Planning Commission Staff Report

Project Type:	Site Development Plan
Meeting Date:	May 29, 2019
From:	Andrew Stanislav, Planner <i>AS</i>
Location:	15320 Conway Road
Description:	<u>SMS Group (15320 Conway Road):</u> A Site Development Plan, Landscape Plan, Lighting Plan, Architectural Elevations and Architect's Statement of Design for a 0.93 acre tract of land zoned "PC" Planned Commercial District located on the south side of Conway Road approximately 500 feet west of its intersection with Chesterfield Parkway East (18S310348).

TRASH ENCLOSURE & RETAINING WALL DETAIL FOR:
15320 CONWAY ROAD - OFFICE BUILDING
CHESTERFIELD, MO

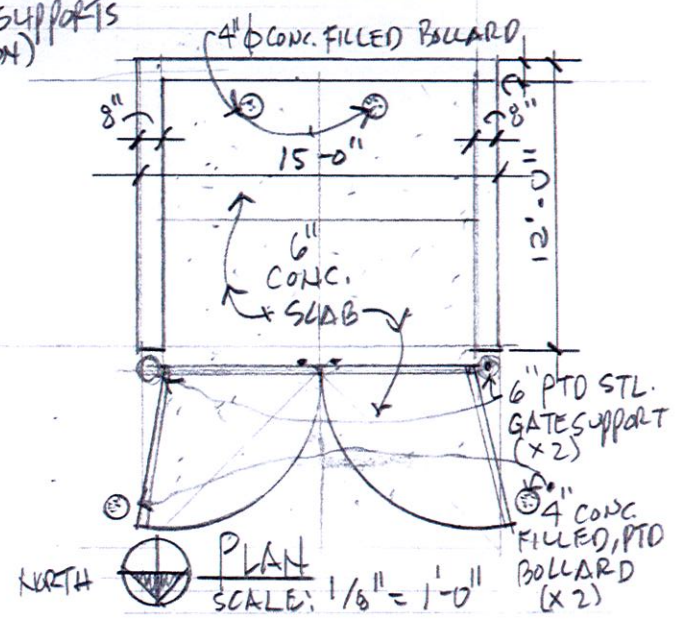
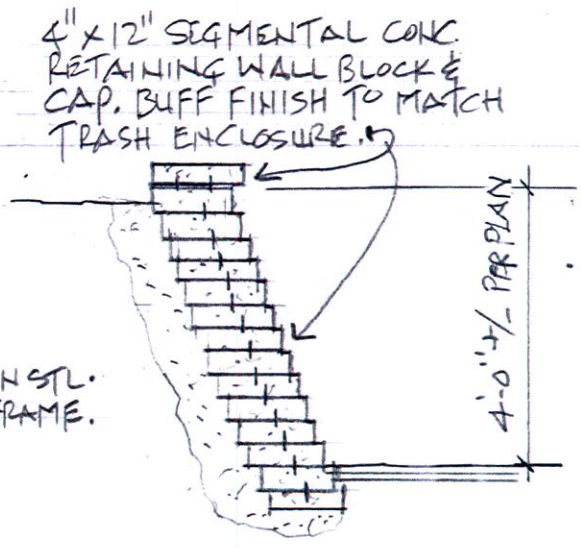
- **Provide details for the trash enclosure and the retaining walls.**

A detail for both the trash enclosure and retaining wall has since been provided and is included in the Staff Report packet. The trash enclosure is eight (8) feet in height comprised of materials complementary to the building, and the retaining wall includes segmental concrete block with a buff finish to match the trash enclosure.
